OREGON PARKS & RECREATION DEPARTMENT  
5330 Seaman Road  
Oregon, Ohio 43616  
(419) 698-7145  
FAX (419) 698-7086

**ADDENDUM No. 1**  
**Recreation Buildings - 2023**

Plan holders of the Recreation Buildings - 2023 Project are hereby notified of the following amendments to the Contract Documents. The following additions, alterations, deletions and/or clarifications shall be part of the bid specifications as much as if they were originally included in the Contract Documents. This Addendum No. 1 is hereby made a part of the Contract Documents and must be receipted for on the proposal form.

E2.2

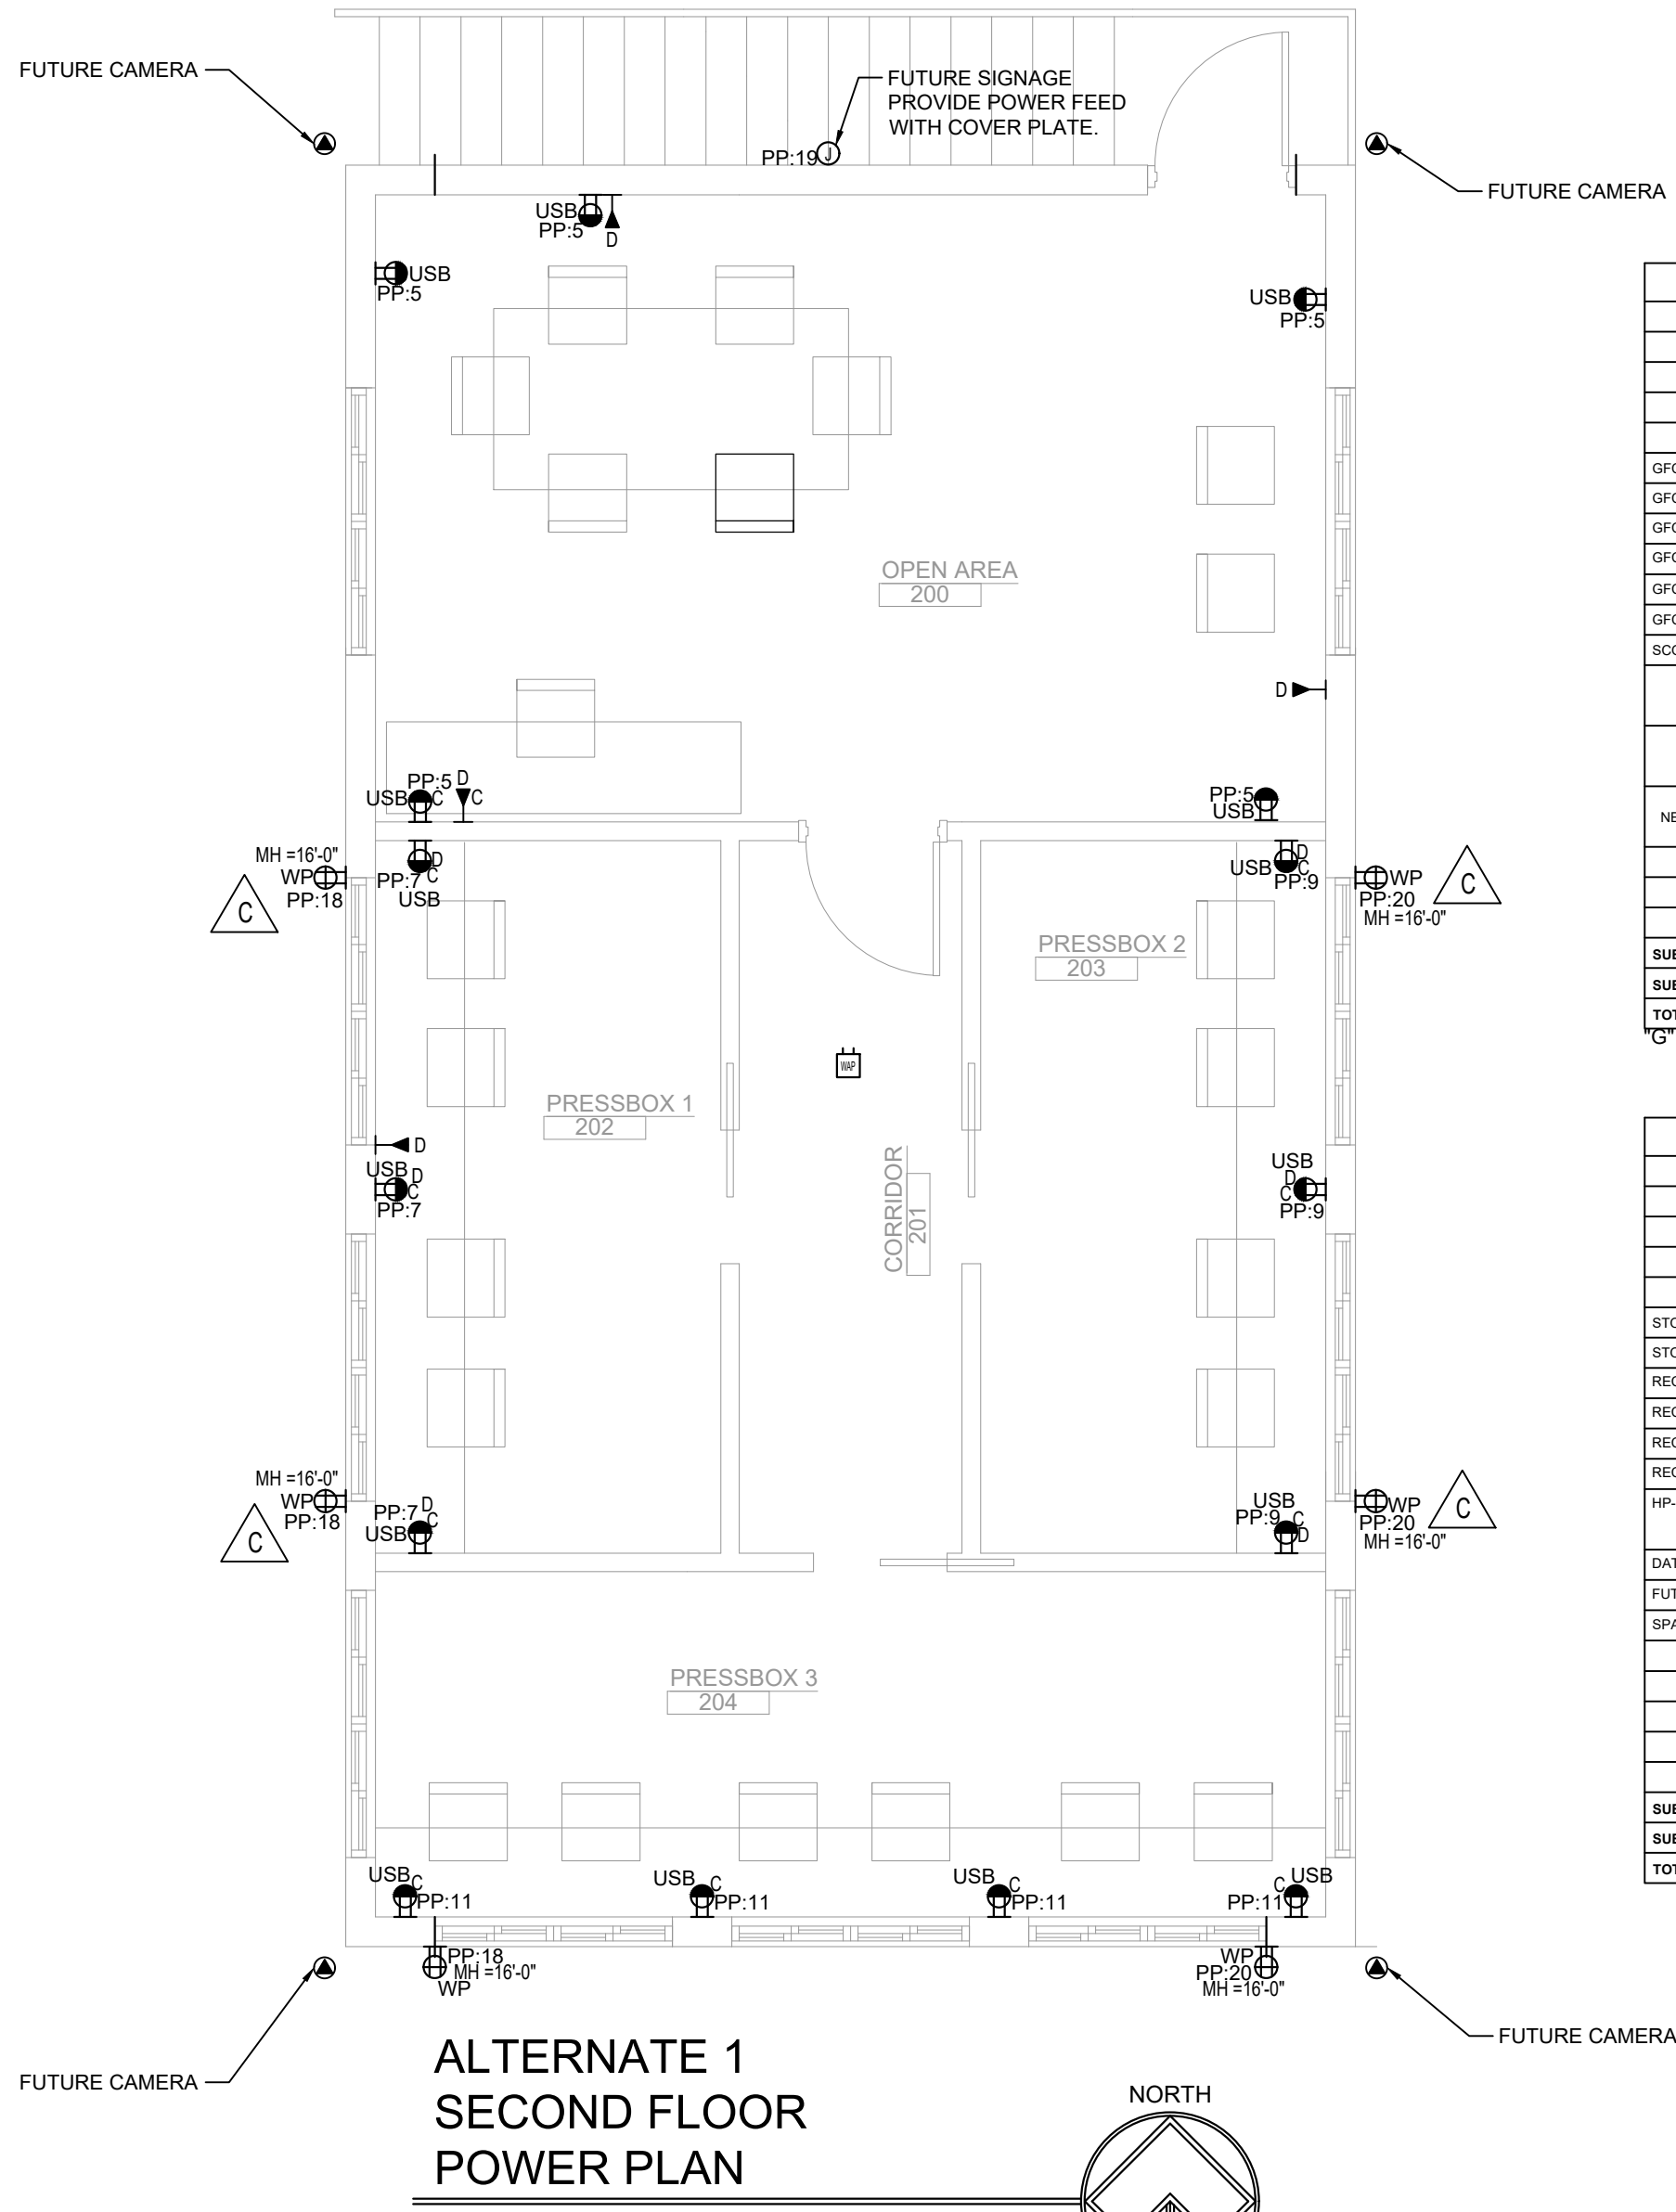
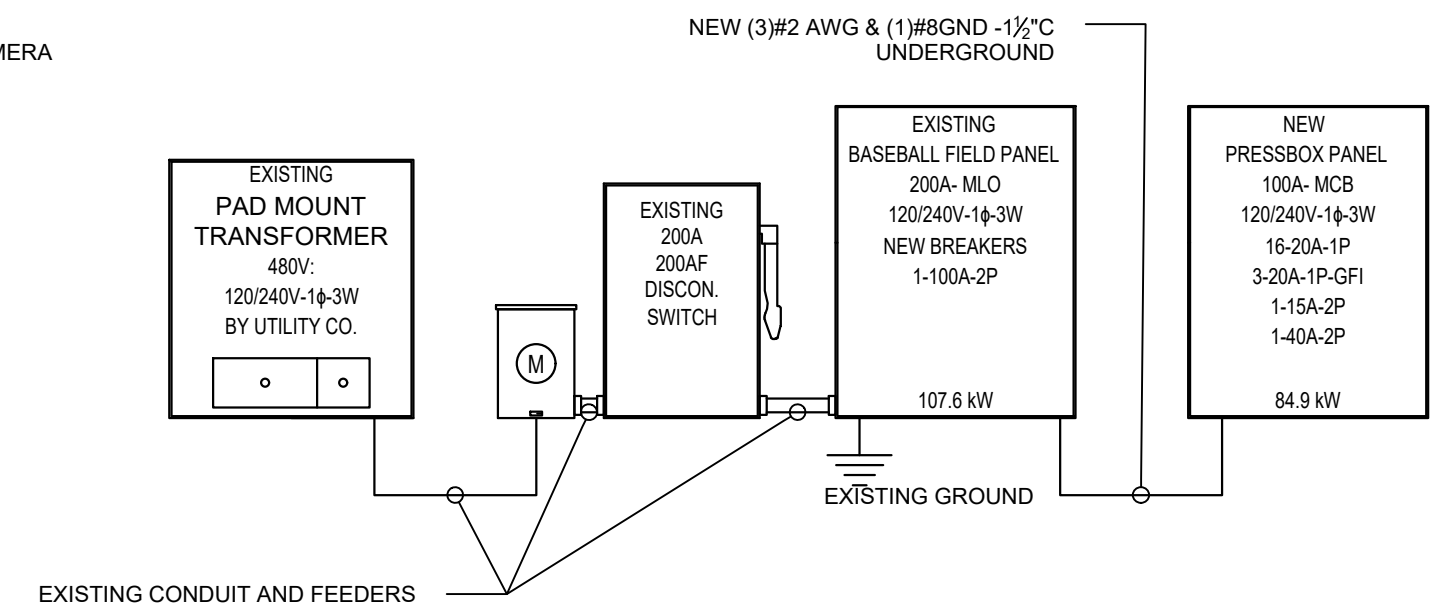
- 6) **Bidder Question:** *The press box does not show a patch panel. Where should the data conduits stub to?*

- 7) **Bidder Question:** *E2.2 the EWC breaker in the panel schedule does not show GFI.*

- 8) **Bidder Question:** *E2.2 Keyed note B. will this be known before rough in? If after rough in there may need to be access provided in the bench to keep code compliance.*

**Architect/Engineer Response:** Data shall homerun to same vicinity as incoming 4" stub for future communications. Refer to sheet E2.2.

**Architect/Engineer Response:** Revised in panel schedule, sheet E2.2 indicates GFI breaker.

**Architect/Engineer Response:** Unknown at this time.
